PROJECT 2: DPD No. 3007492 | 1001 Mercer Street
DPD No. 3007493 | 1021 Mercer Street

03.06.2008 | Design Commission #3
LMNARCHITECTS

12/20/07 Design Commission Recommendations and Comments

DESIGN COMMISSION #2 PLAN

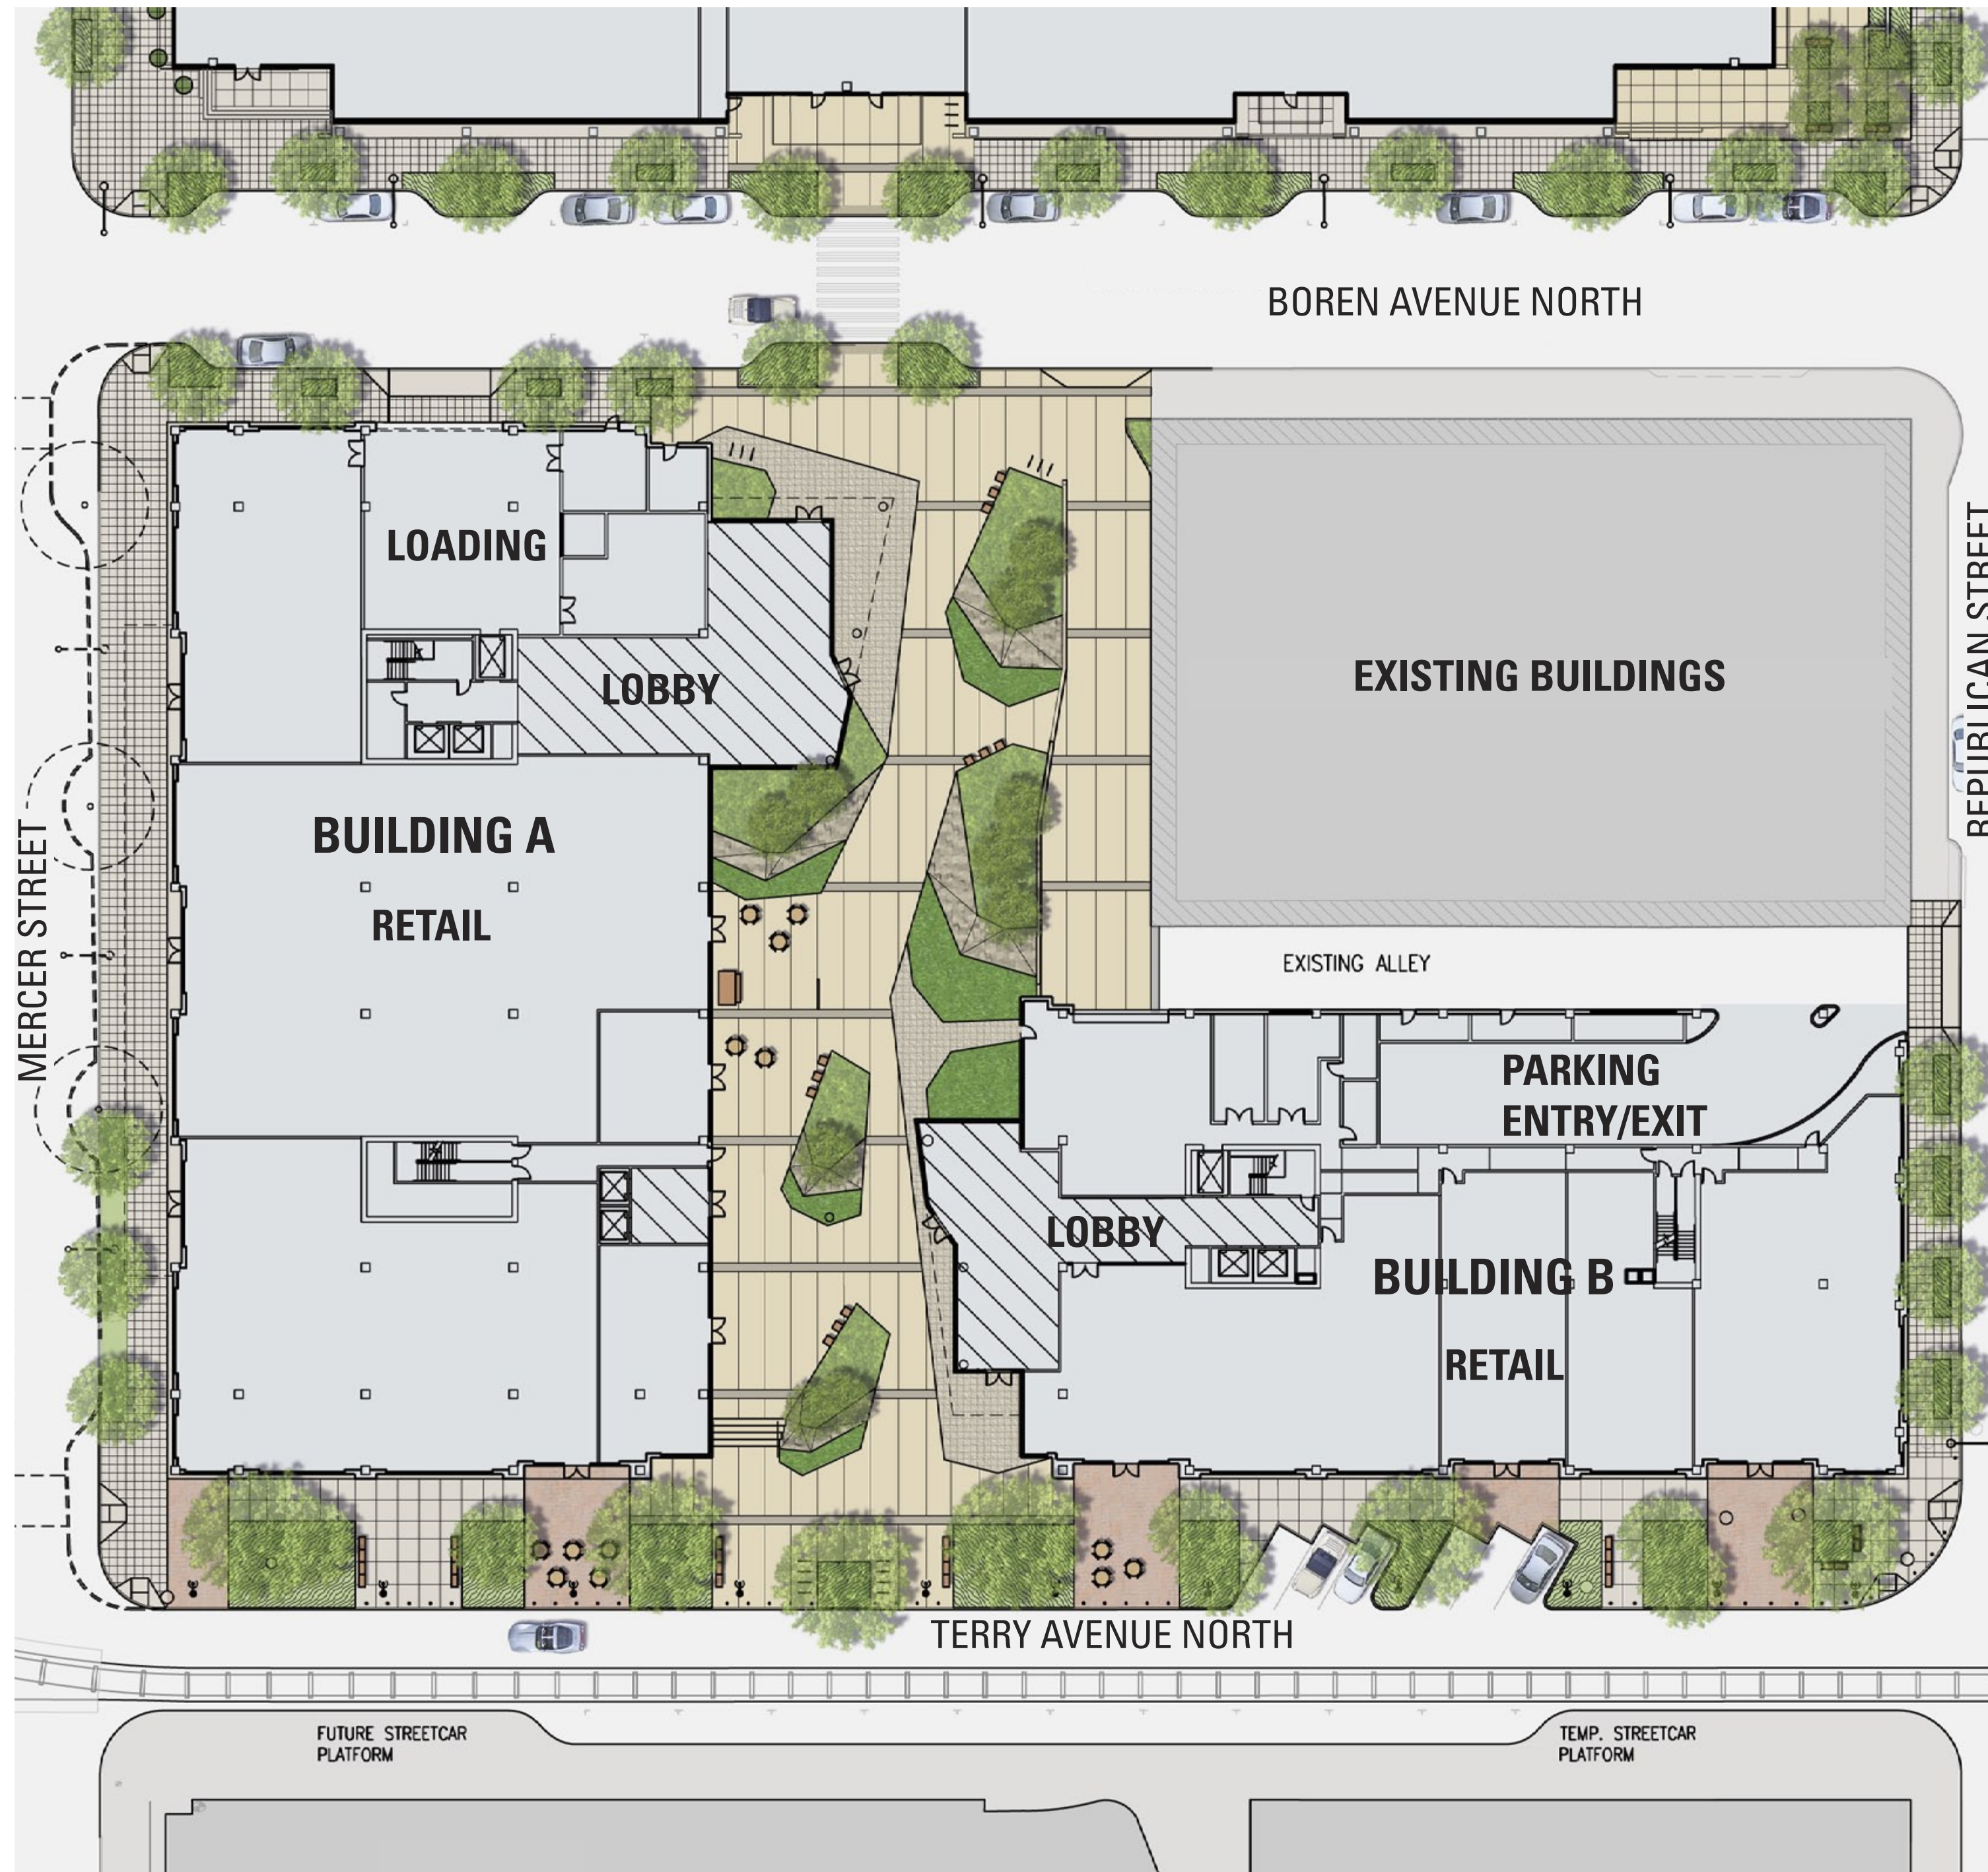
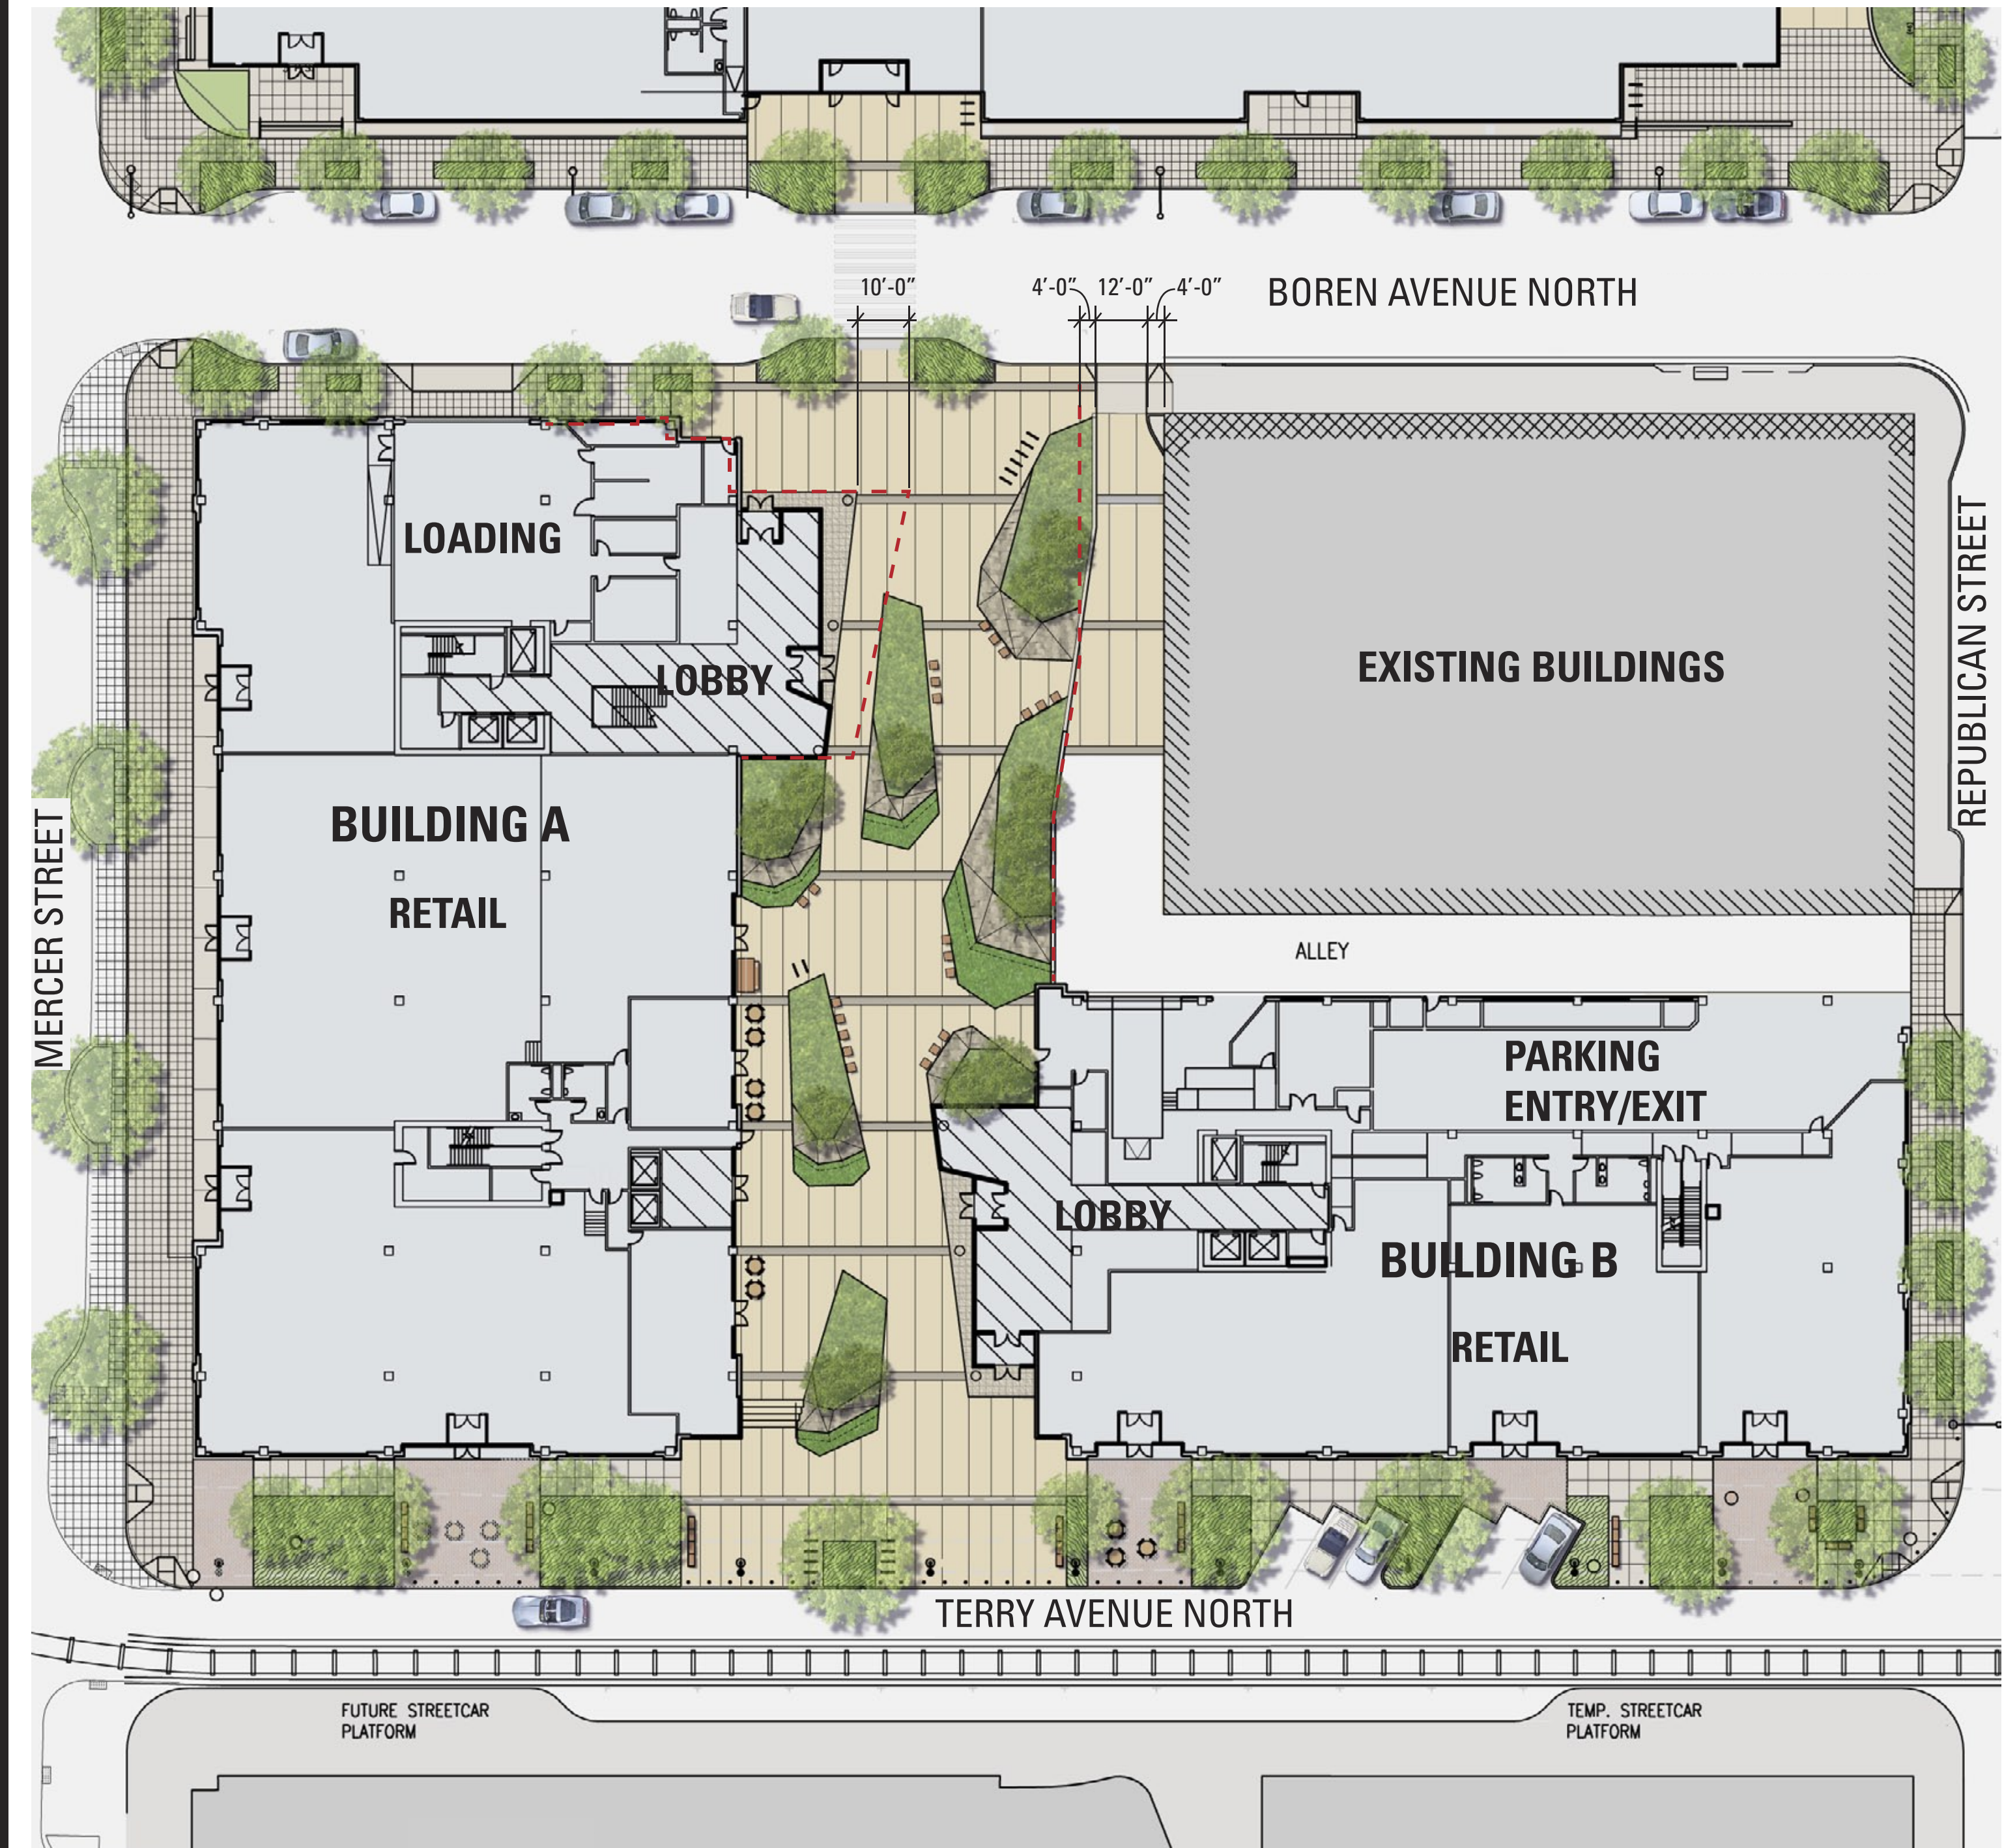
- The alley/plaza entry at the Boren side feels constrained and less inviting than the plaza entry on Terry. Also, the plaza paving in the alley may give false signals to encourage pedestrian in the alley.
- Support the consideration of narrowing the alley entrance on Boren, which is subject to SDOT review.
- Narrow alley width on Boren to add width to the public plaza.
- Support lobby on the east being moved a little north which would support the entrance into Building A.

- The north side of the courtyard is dominated by retail storefronts, but it would serve the public well to use these sunlit areas for public seating and gathering independent of commercial activities.
- Give attention to making the space more clearly readable as a public space.

We have reduced the lobby protrusion on Building A by approximately 10 feet on its Boren Avenue side. We have also narrowed the Boren Avenue end of the alley from 20 feet to 16 feet and have gained SDOT’s acceptance of this modification. Together these changes have the effect of opening up the Boren side of the plaza. We have revised the majority of the alley paving (that portion utilized for loading functions) to be different from the plaza paving in order to avoid the false signal to pedestrians.

We have modified the locations of several landscape islands to make the central sunlit courtyard area more public and less “owned” by the retail spaces. We have also added more fixed seating in a variety of spaces that should help to entice the public to use the courtyard and understand it as a public space.
